Work Order ID 100034

Item ID: D206-667-103

Item Name: Crosstube Fwd

DRAWING NO. D206-667-143	TITLE CROSSTUBE ASS'Y (206L HIGH FWD)	REV. C	DART AEROSPACE LTD ENGINEERING ORDER		DESIGN NO D206-667-143-C-1	SHEET NO SHEET 1 OF 1	SCALE NTS
DRAWN 97	CHECKED ASS	MFG. APPR. 125	APPROVED WJ	DE APPR. WJ			
DATE 11.07.15	DATE 11.07.20	DATE 11.07.21	DATE 11/07/21	DATE 11.07.21

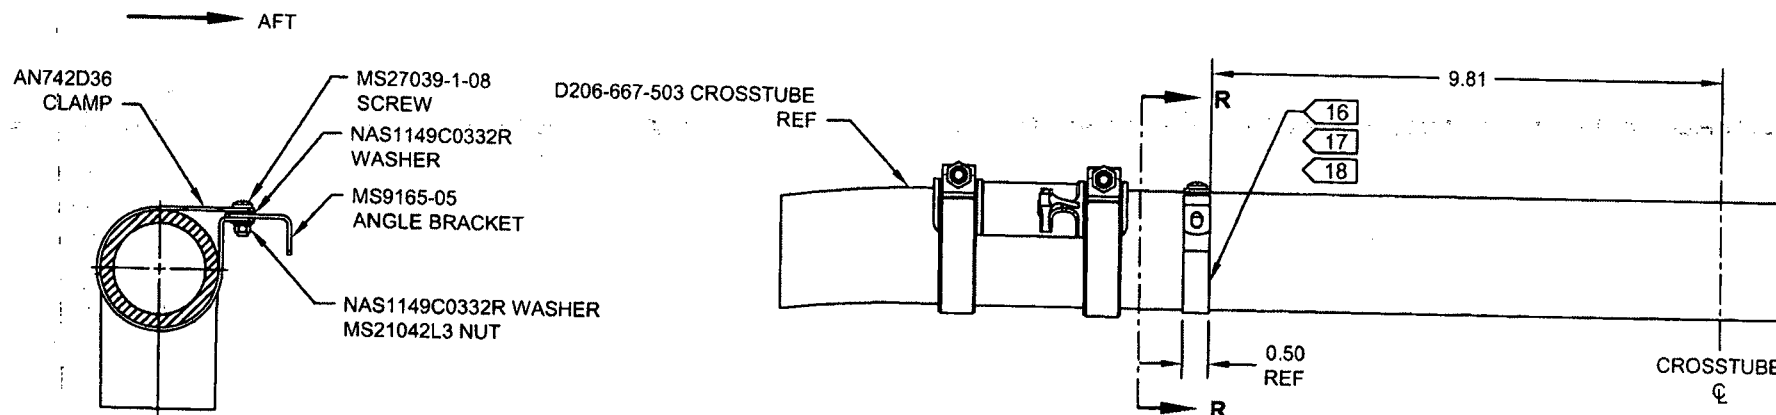
REPLACE MAGNOBOND WITH PROSEAL.

NOTE 12 & 15, SHEET 1 IS AMENDED AS FOLLOWS:

- 12) TO INSTALL D2891-1 SUPPORT: ABRASE MATING SURFACE OF SUPPORT AND CROSSTUBE WITH 180-GRIT SANDPAPER AND REMOVE RESIDUE WITH MEK (OR EQUIVALENT). APPLY A 0.04" TO 0.07" THICK LAYER OF PROSEAL 890 CLASS B-2 (OR AMS-S-8802 CLASS B-2) SEALANT TO MATING SURFACE OF SUPPORT.
- 15) TORQUE CLAMPS 80 TO 100 IN-LB. ENSURE AT LEAST 1.5 THREADS SHOWING IN SAFETY AND THAT NUT HAS NOT BOTTOMED-OUT AFTER TORQUING. **PRIOR TO PACKAGING, RE-CHECK TORQUE ON CLAMPS AFTER PROSEAL 890 SEALANT HAS CURED FOR 72 HOURS.**
